Contract #: 04-0120F4
 Cty: SF/ALA Rte: 80 PM: 13.2/13.9
 File #: 69.25B

QUALITY ASSURANCE -- NON-CONFORMANCE REPORT

Report No: NCR-000366

Reference Description: Heat Straightening of BK2A

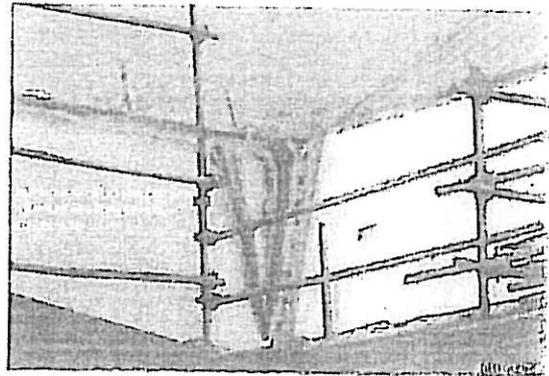
Quality Assurance Representative observed heat straightening operations being performed on the Bike Path Cantilever Brackett located at Panel Point 11 of Segment 1BE. ZPMC production personnel performing the work presented, when requested, ZPMC's internal Heat Straightening Record 1(B) 7055, which described a procedure that varied from the operations observed. The variations included the locations for the application of heat, the use of jacks and the use of a block and chain/cable to apply active pressure after heating. In addition, the anchor point of the block and chain/cable was observed to be the Mechanical Electrical Penetration (MEP) at Panel Point 10.5. The MEP was observed to be leaning toward the direction of the load while the cable was tensioned and after the load was released the MEP was measured to be 2mm out of plumb. The deck area immediately adjacent to the MEP and opposite the direction of load was observed to be slightly upset. This upset is visible but within tolerance of the specifications.

ZPMC's internal Heat Straightening Record I(B) 7055. The procedure illustrated the locations for the application of heat and specified the need to complete the task by only flame straightening.
Caltrans Standard Specifications, Section 55-1.04 Shipping, Handling and Storing Materials. In handling and shipping of steel work, every care shall be taken to avoid bending, scraping or overstressing the pieces.

The contractor will repair according to HSR1(B)-6669 and perform NDT verification.

The contractor has verified the affected welds with NDT. Acceptable NDT documentation result is provided.

Heat Straightening Record (HSR1)

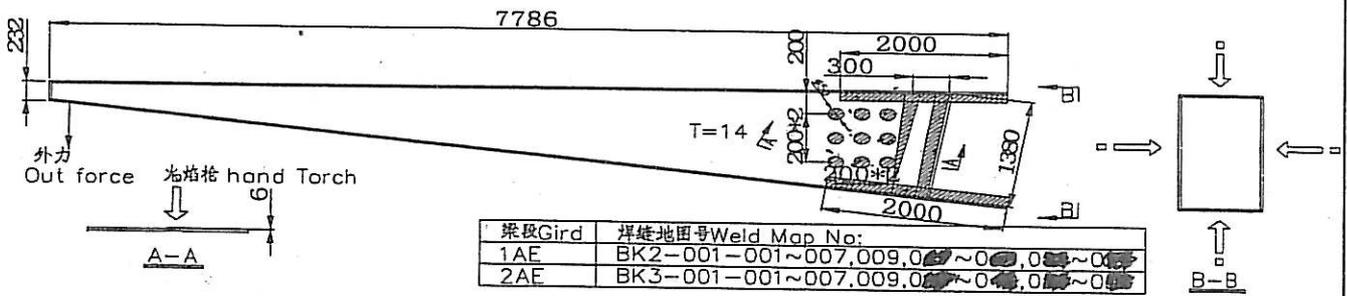
注: 最大变形量约 6mm, 校火宽度 50~100mm.

NOTE: the max deformation is about 6mm, heat straightening the width is 50~100mm.

Flame Straightening by oxygen acetylene 运用氧乙炔进行校火

After finishing heat straightening, the weld of the heat area shall perform NDT according to the approved shop drawing 校火后, 根据图纸要求对热影响区域进行 NDT 检测。

Subject: Fabrication Issue: Propose to Introduce CJP Splices in Bikepath Cantilever Beam Deck & Web	
References:	
Sub/Sup: ZPM	Sub RFI #: RFI-ZPM-000694R01
Response Required by: 27-July-2009	Response affects critical path activity? Yes

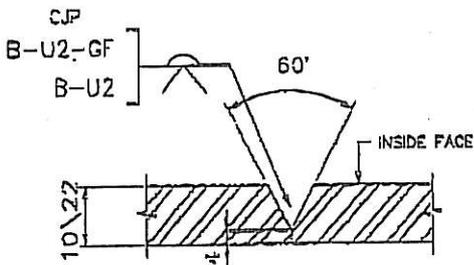
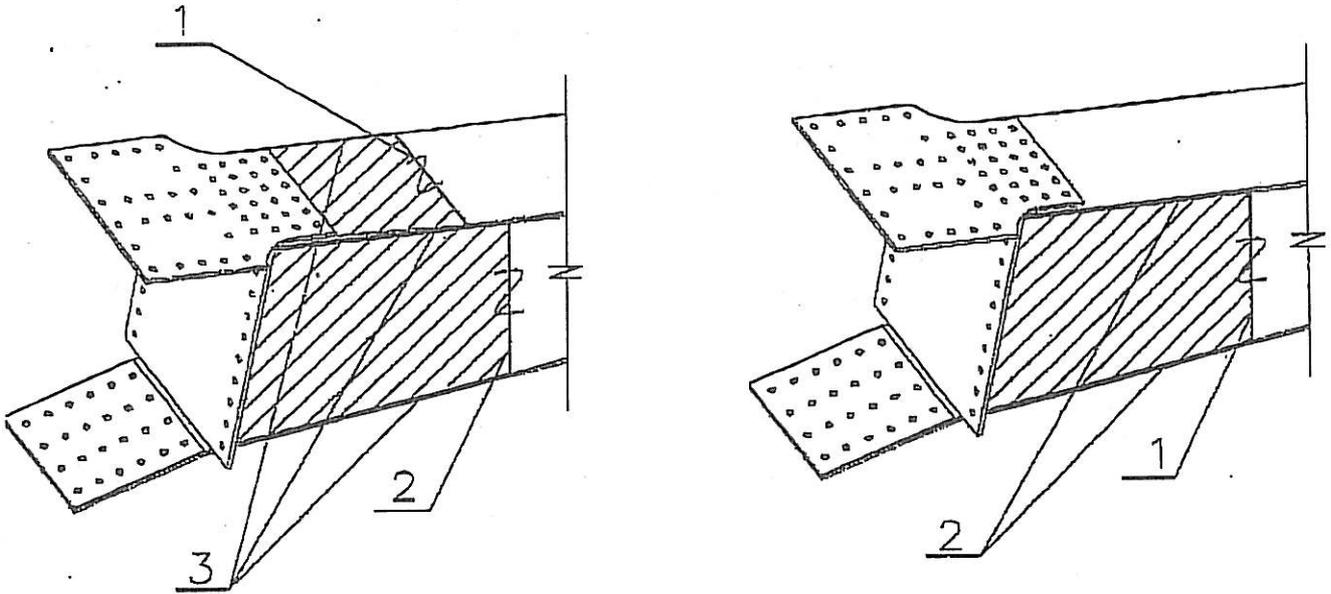
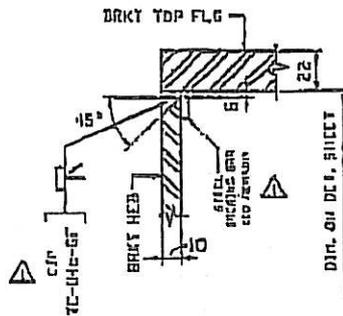
After the fabrication of bikepath cantilever beam, ZPMC finds that the flatness of deck & web will be difficult to adjust. Therefore, ZPMC proposes to introduce CJP splices in bikepath cantilever beam deck & web. See attached drawings for the proposed locations.
 For the welding sequence see the sketches below. The marked up top and web plates at BK2 & BK3 will be replaced. For the welding detail see the WD below. 100%UT and 100%MT will be performed on these welds.

It is understood that no backing bar is used for any transverse welds. Backing bars are only acceptable to remain for the longitudinal welds.

The recommended repair method for the discontinuous longitudinal backing bar is to feather the ends of the bars to form a smooth transition. This transition shall be achieved by transitioning the backing bar termination with 50mm long concave fillet welds. The clear distance between the backing bar complete removal transition should be at least 150mm.

It is not acceptable to add new copes to the bikepath cantilever beam

The Contractor's proposed inspection of the repair is acceptable.
